FIELD SERVICE BULLETIN

FSB Number: BJCCFSB2004 - 211
Author: Xu Changhong
Date: 8 November 2004
Total No. Of Pages: 3
Subject: **GSM EZX (A780) Keypad no function due to G-Flex broken**
Model Affected: **EZX (A780) Quad Band**
Level of Repair:

Fig. 1

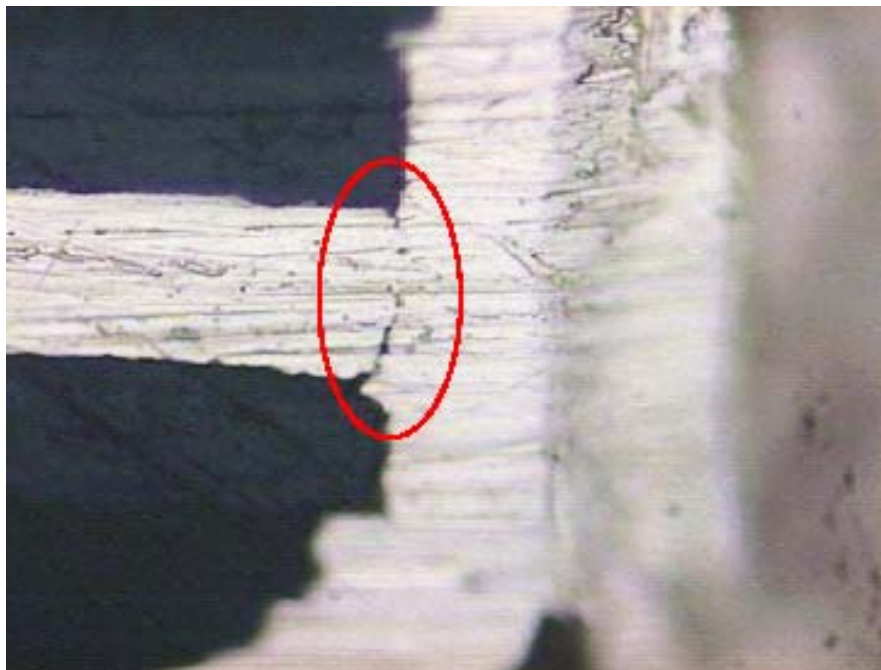
During the A780 NPI analysis the "Keypad no function" is highlighted as the Top #1 issue which accounts for 10% of Octobers field returns. Supplier FA report show that the "**(G-) flex cable broken**" resulted in the keypad no function.

Figures 1 & 2 illustrate the detailed failure mode. There is a narrow slot at the junction area of that is between the hole and the nearby circuit. This is a supplier process issue.

Slot can be seen obviously
under 500X magnification.

Supplier (Gflex and TOEC) detected the above problem and took below corrective action .

1. All the old date code parts (before 4004) should be scrapped in Gflex
2. In the Gflex new process the PTH is adopted for the new date code parts building instead of the old process (shadow)
3. Old assembled parts were purged in TOEC at the end of Sep. From wk42, TOEC started using the parts with **new date code 4004**
